CITY PLANNING COMMISSION AGENDA

CPC SWP 16-00155 – SUBDIVISION WAIVER – QUASI-JUDICIAL
CPC PFP 16-00156 – PRELIMINARY/FINAL PLAT – QUASI-JUDICIAL
CPC NV 17-00141 – NON-USE VARIANCE – QUASI-JUDICIAL

PROJECT: ROBBIN PLACE DUPLEXES
APPLICANT: MR. PAUL RISING
OWNER: TARA CUSTOM HOMES, INC.

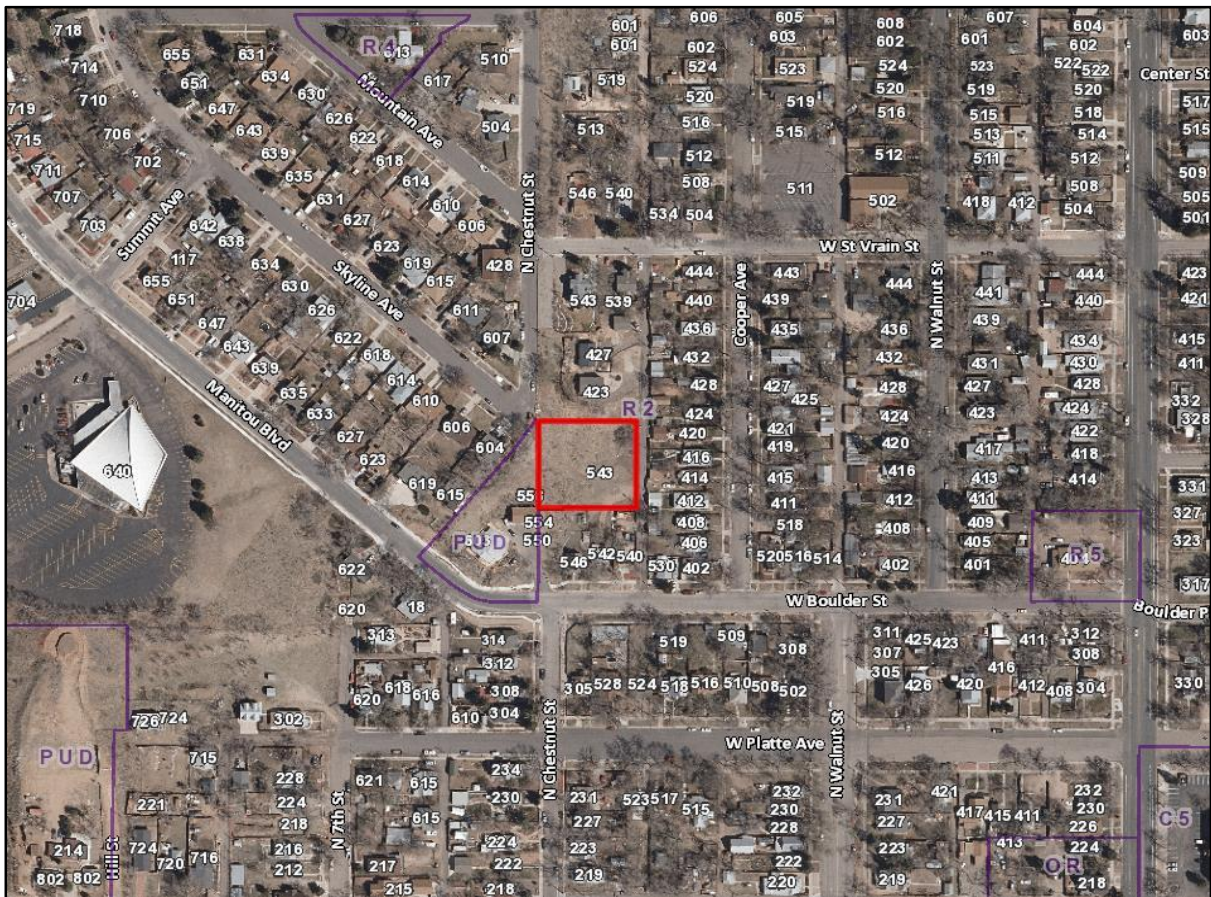
- 1. Revise the note numbering on page 1, there are two note ones.***
- 2. Correct Mat to May for the date in note number 5.***
- 3. Change the words “preservation easement” to “preservation area” on the preliminary/final plat.***

- 4. On sheet 3 update the label for the cross-pan at Boulder St from "MATCH EXISTING CONCRETE PAN." to "REMOVE AND REPLACE CROSS-PAN"***
- 5. Clean up plan notes for water/wastewater service lines. Other notations are overwritten on top of them.***

- 6. Ensure water and wastewater services are located 15' from any property line where gas/electric service lines will be installed. The wet utility services are in conflict with the gas and electric services.***

- 7. Complete and submit the HGL Request form to CSU. Provide a copy of the HGL Response with resubmittal. Revise the Preliminary Utility sheet per the comments received.***

- 8. Remove the existing contours on the Preliminary Utility and Public Facility Plan sheet.***
- 9. Update the final alley pan design schematic utilizing appropriate fire apparatus dimensions and verify approval by City Fire.***
